Wisconsin Department of Transportation

Proposal #02: 3997-01-74, WISC 2023404
City of Watertown, Cady Street
Rock River Bridge P-28-0706
Loc Str
Jefferson County

This is Addendum No. 01, which provides for the following:

Addendum No. 01
ID 3997-01-74
Revised Sheet 10
April 25, 2023

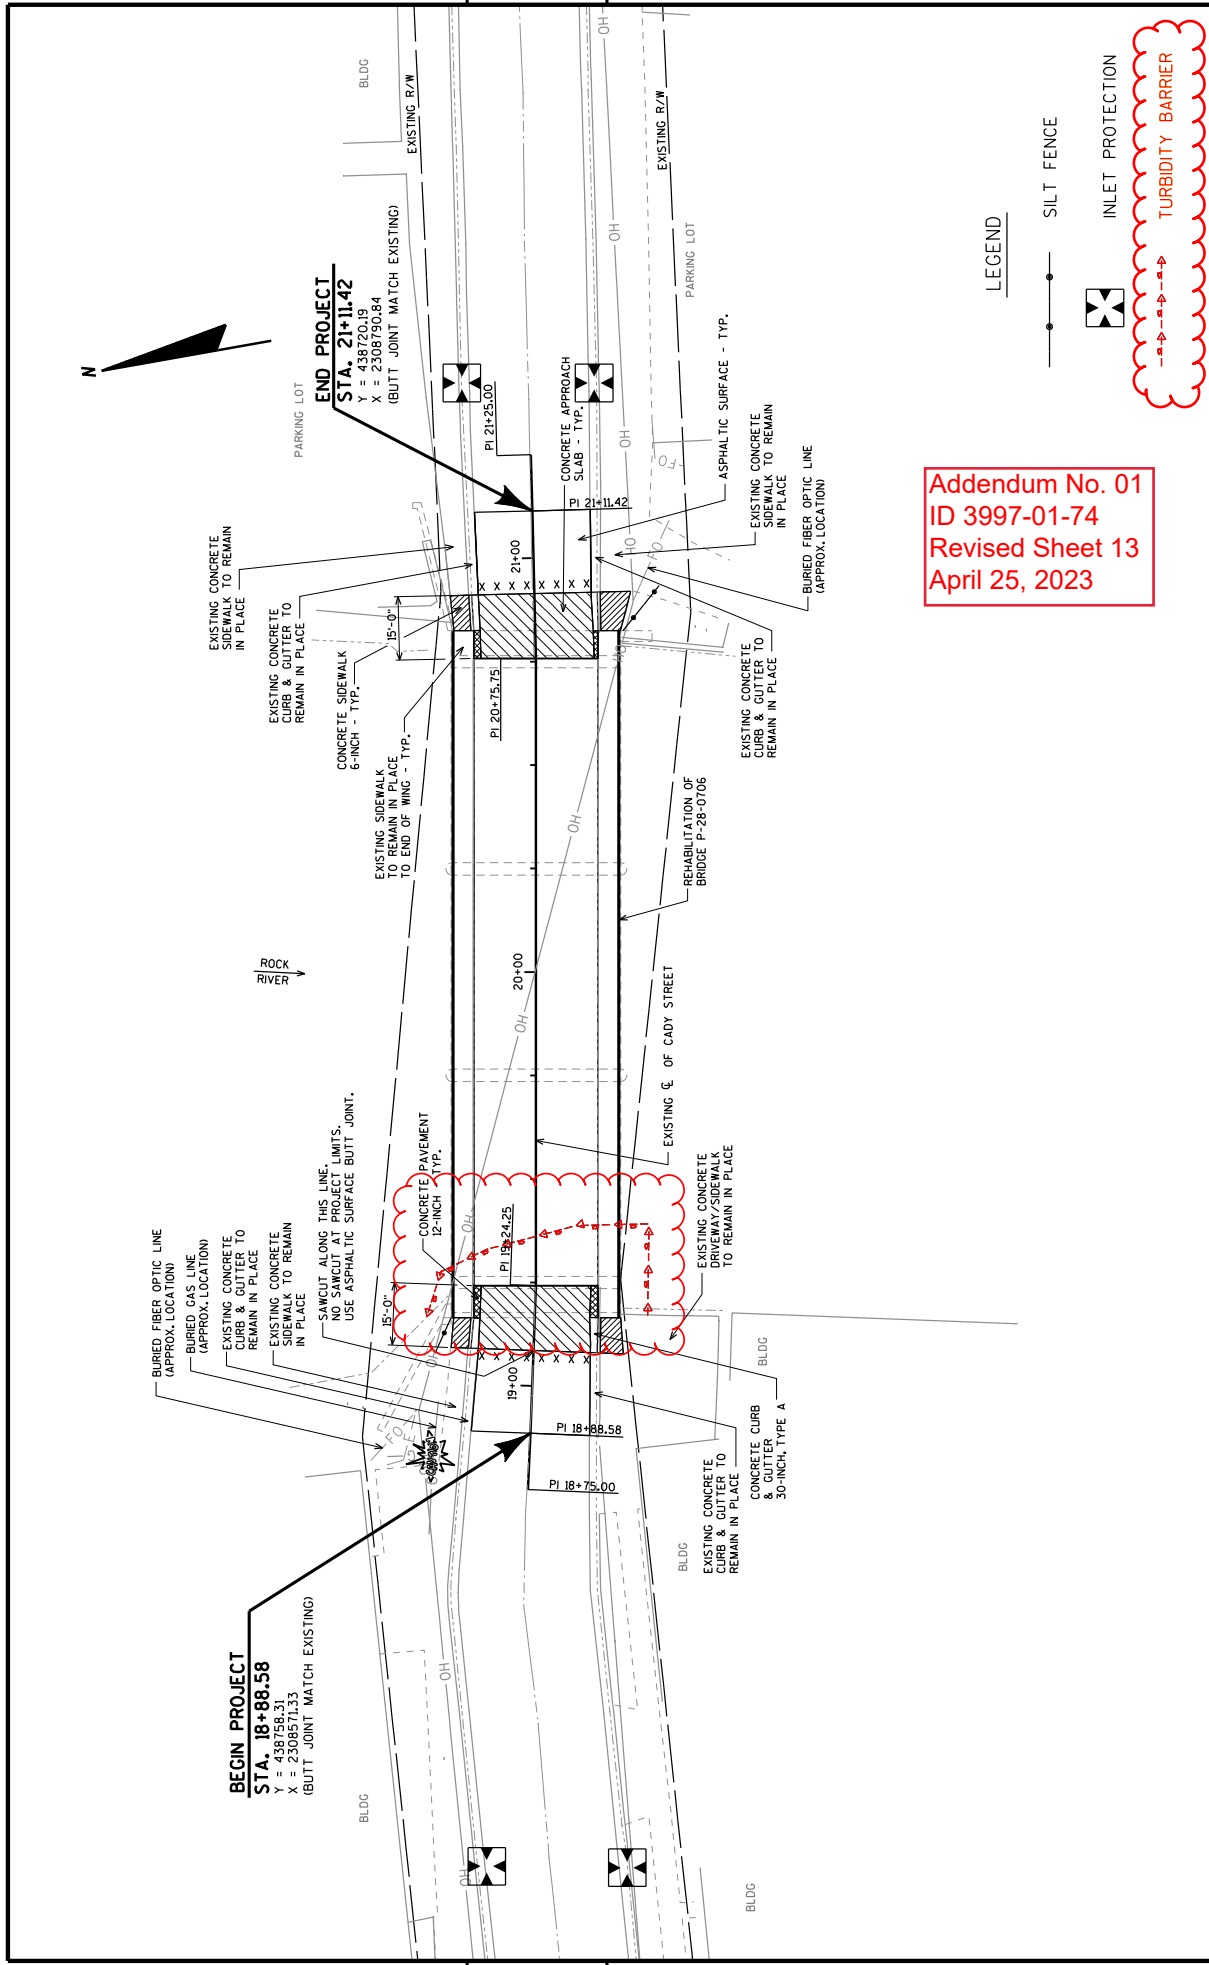
Revised Plan Sheets	
Plan Sheet	Plan Sheet Title (brief description of changes to sheet)
10	Miscellaneous Quantities: Added bid item and quantity for turbidity barriers
13	Plan: Added turbidity barrier to plan view and legend
28	Structure P-28-706 General Plan: Added area of underwater concrete surface repair to elevation view.
29	Structure P-28-706 Typical Section, Quantities, & Notes: Revised quantity for concrete surface repair in quantity table. Added bid item and quantity for underwater concrete surface repair in quantity table

Addendum No. 01
ID 3997-01-74
Added Sheet 17A
April 25, 2023

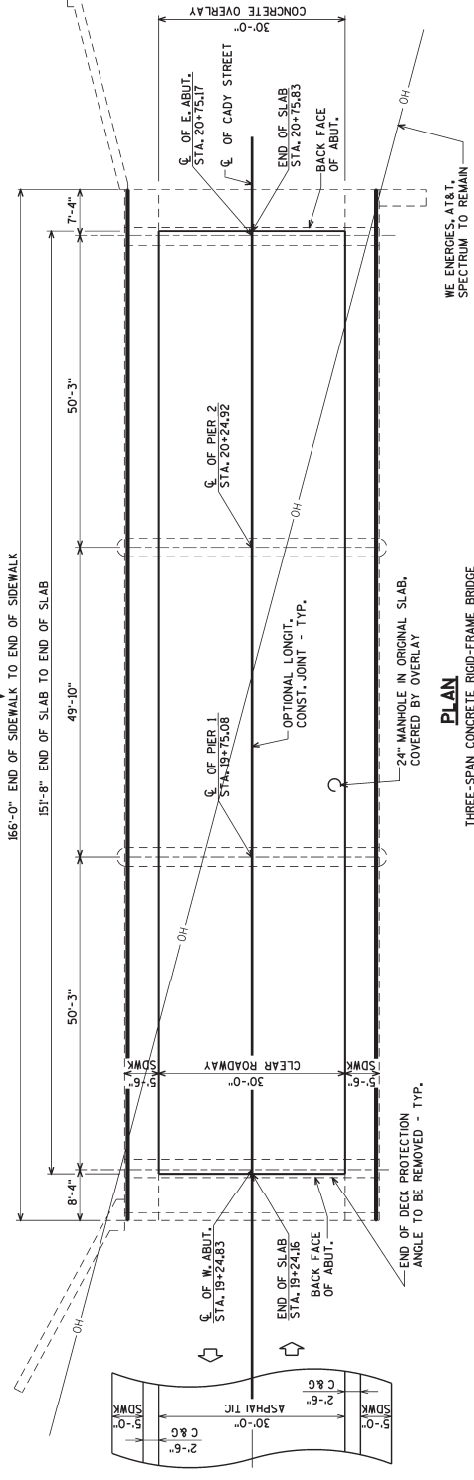
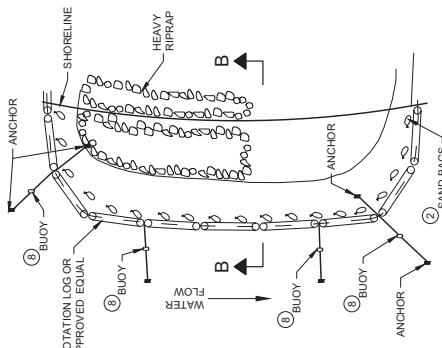
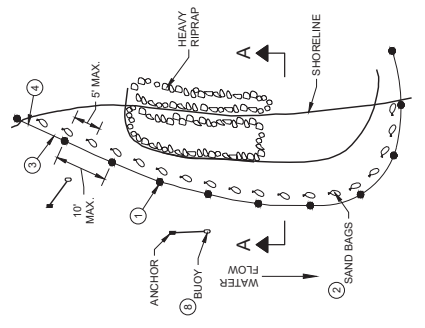
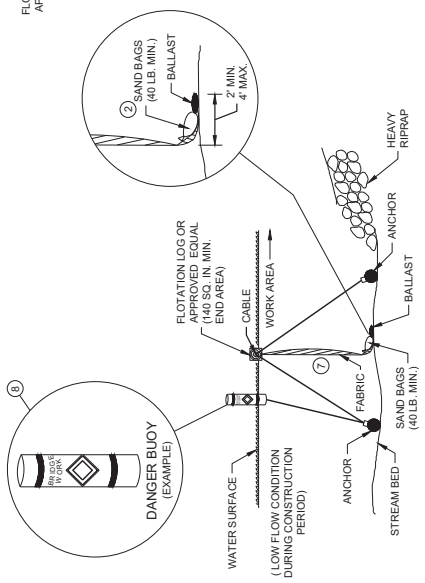
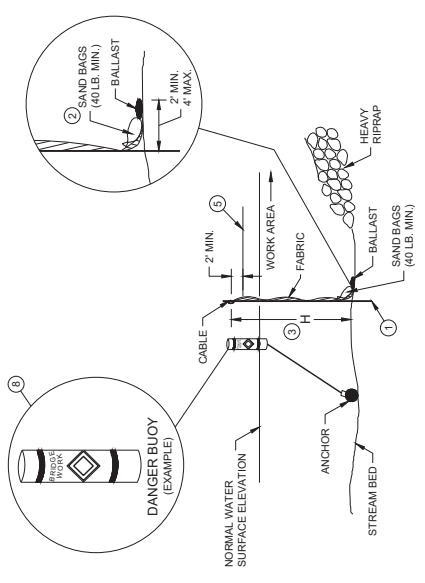
Added Plan Sheets	
Plan Sheet	Plan Sheet Title (brief description of changes to sheet)
17A	SDD: Turbidity Barrier

Addendum No. 01
ID 3997-01-74
Revised Sheet 28
April 25, 2023

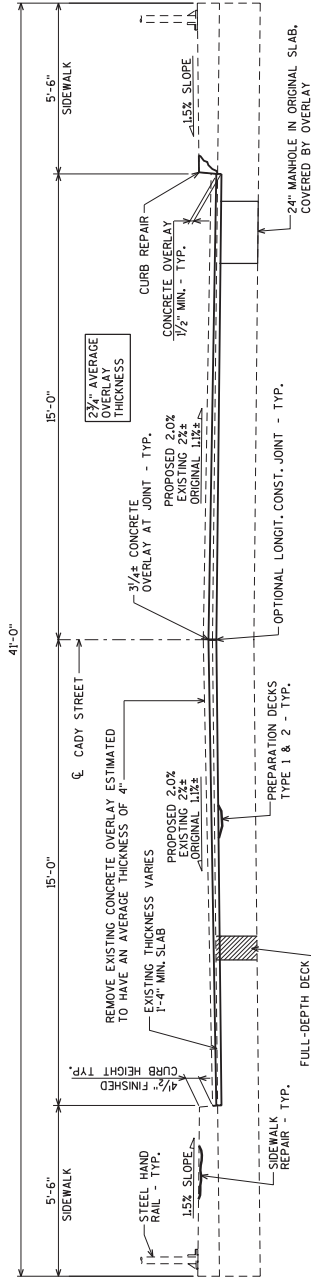
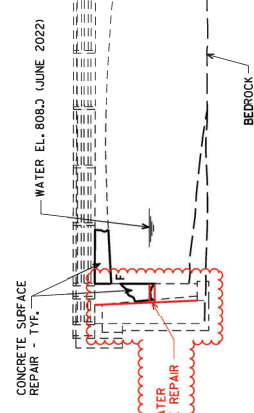
NO.	DATE	ADD UNDERWATER SURFACE REPAIR	REVISION	BY
1	04/23			AYRES

NOTE:
CONCRETE SURFACE REPAIR
REQUIRED AS DIRECTED BY THE
ENGINEER IN THE FIELD.
